TO: Mercedes-Benz Dealer Principals, General Managers, Sales Managers, Service Managers, Parts Managers	FROM: Gregory Gunther, Department Manager, Vehicle Compliance and Analysis, Engineering Services
RE: Service Campaign Launch Notification Check Transmission Bearing Cover MY20-21 GLA-Class and GLB-Class (156/247 platform)	DATE: February 24, 2023

Check Transmission Bearing Cover

Campaign No. 2022110007, December 2022

Replace Transmission Bearing Cover

Figure 1

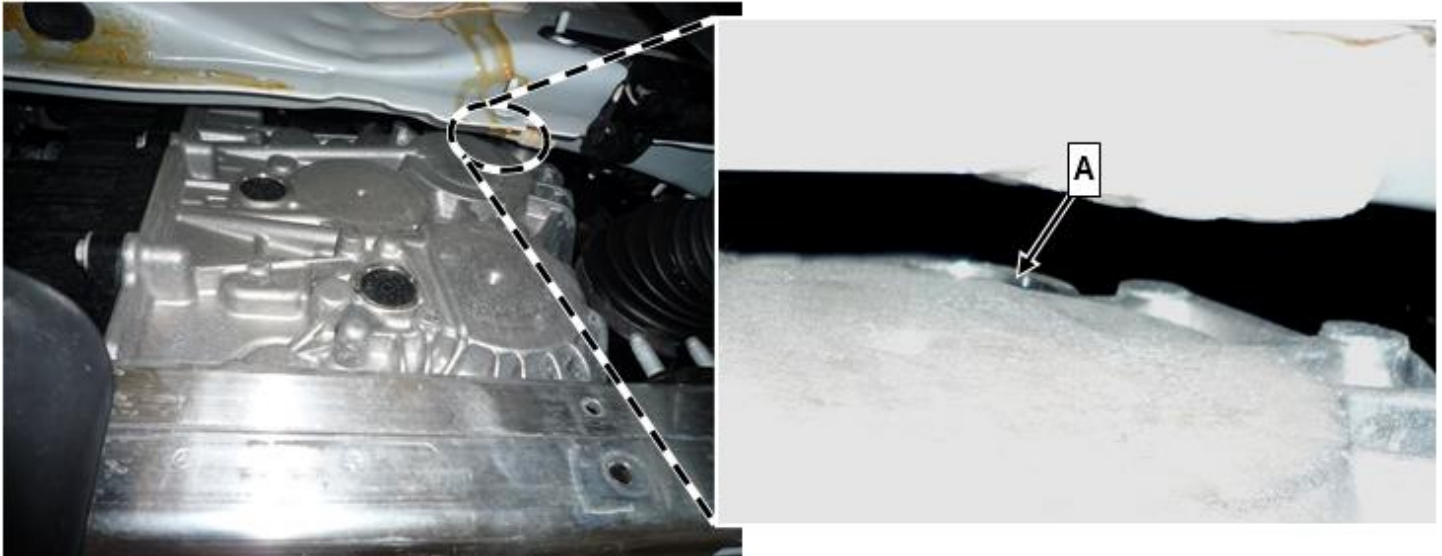
2. Check bearing cap (A, figure 1) on transmission with a mirror.

i A **bright aluminum bearing cap** must be installed here.

- a. Bright aluminum bearing cap **not** installed on transmission: Perform **work procedure**.
- b. Bright aluminum bearing cap installed on transmission: **End measure**.

Figure 2

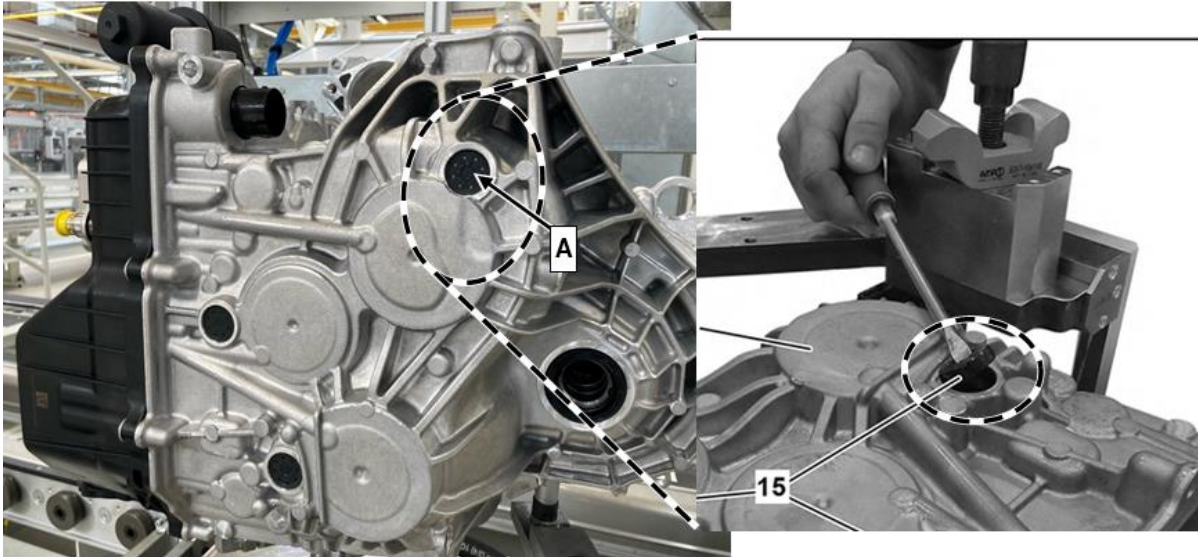
1. Remove engine with transmission.
 For basic data, see AR01.10-P-2401*.
 * Select the WIS document according to the vehicle model.
2. Remove bearing cap (A, Figure 2) from transmission using a suitable tool.
 The bearing cap will be replaced by a **new aluminum bearing cap**.

3. Insert new aluminum bearing cap up to end stop and hammer in slightly.
 4. Assemble in reverse order.
-
